**The City of Lake Forest
Building Review Board Agenda**

**Wednesday, October 7, 2020
Remote Access Meeting**

Agenda Item 3
114 Washington Circle
Additions, Demolition of Existing Garage, New Replacement Garage,
Building Scale Variance

114 Washington Circle

Proposed Left Side Elevation

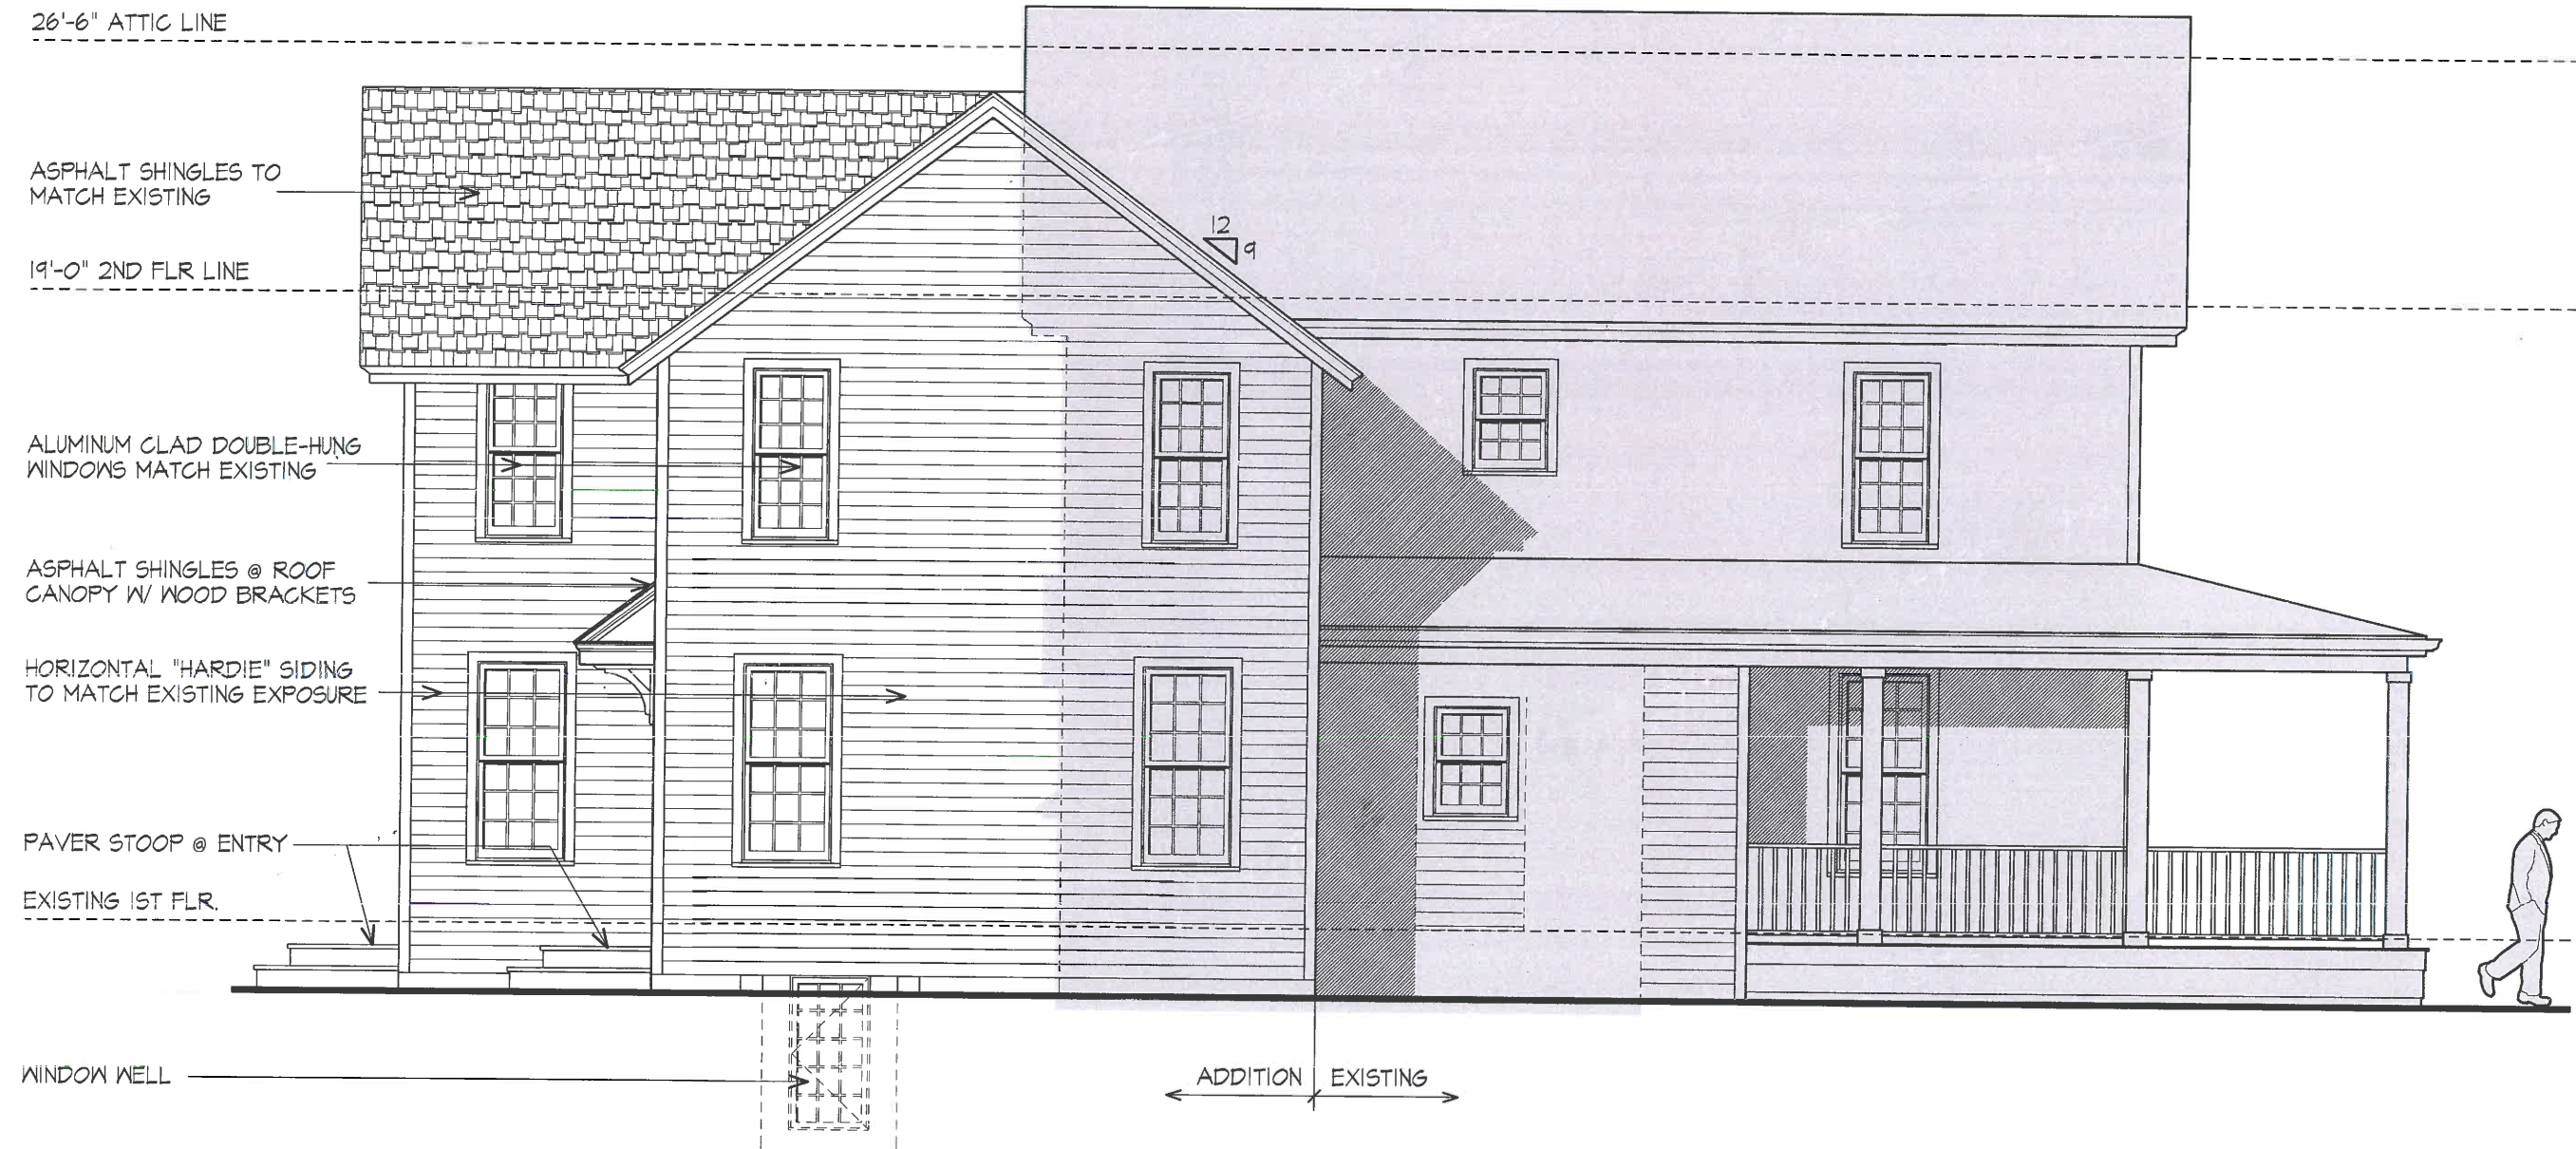
This standard is met. The two-story addition is proposed on the southwest side of the house, and partially behind the existing home. The addition is also set back 25 feet from the front of the home, helping to minimize its impact on the streetscape.

This standard is generally met. The two-story addition is 27 feet and 3 inches tall, and is 2 feet and 6 inches lower than the height of the existing home. A previous concept submitted by the petitioner proposed a taller addition but after some study, the height of the addition was lowered in an effort to lessen the appearance of mass and allow the addition to be subordinate to the existing home.

Landscape Plan

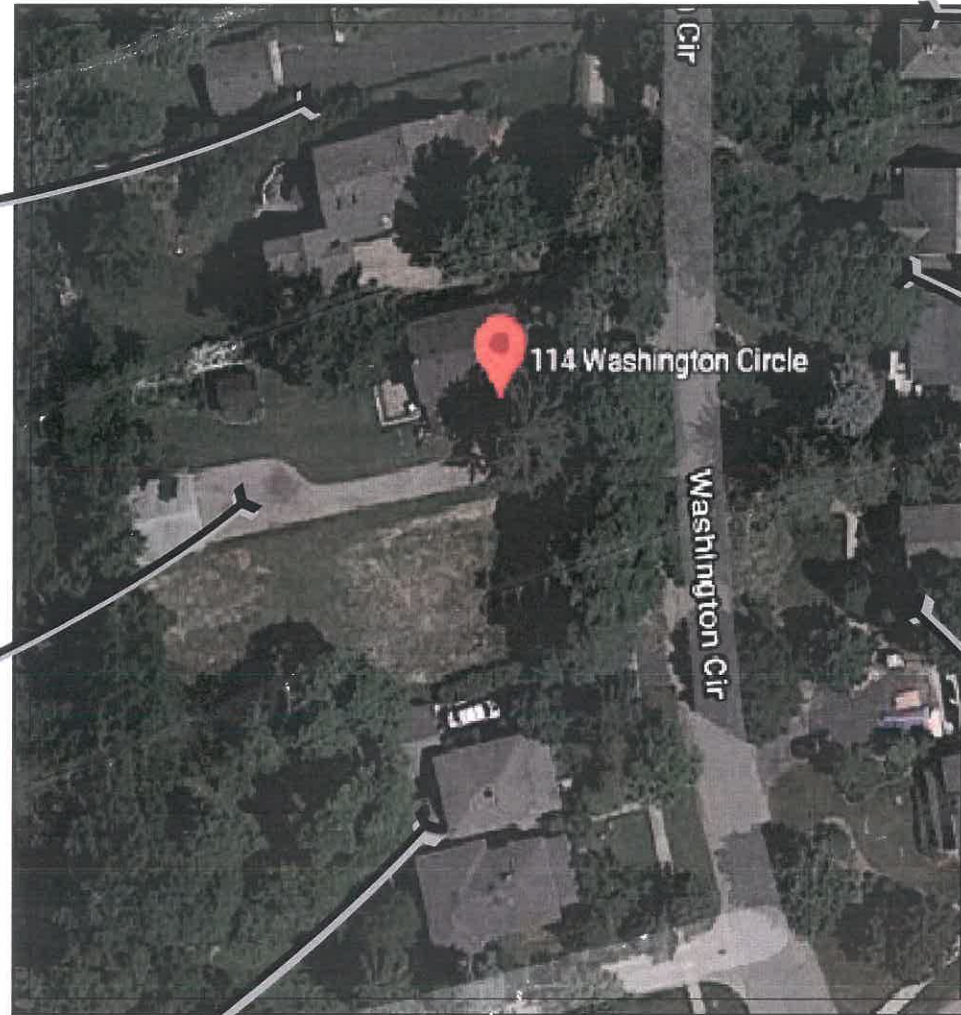
The proposed work is not expected to impact any existing trees on the site. A landscape plan was submitted by the petitioner and is included in the Board's packet. The plan shows the existing landscaping on the property with new plantings around the foundation of the existing home, proposed addition and replacement garage. New plantings are also proposed along the north and south property lines and in the front yard. New plantings include Maple and Redbud trees, a variety of shrubs, grasses and ornamental plantings.

2. A final landscape plan shall be submitted and will be subject to review and approval by the City's Arborist. Particular attention shall be paid to assuring sufficient screening along the property lines either through existing vegetation or, additional plantings if it is determined by the City's Certified Arborist that additional screening can be accommodated to reasonably screen the appearance of the additions and garage.
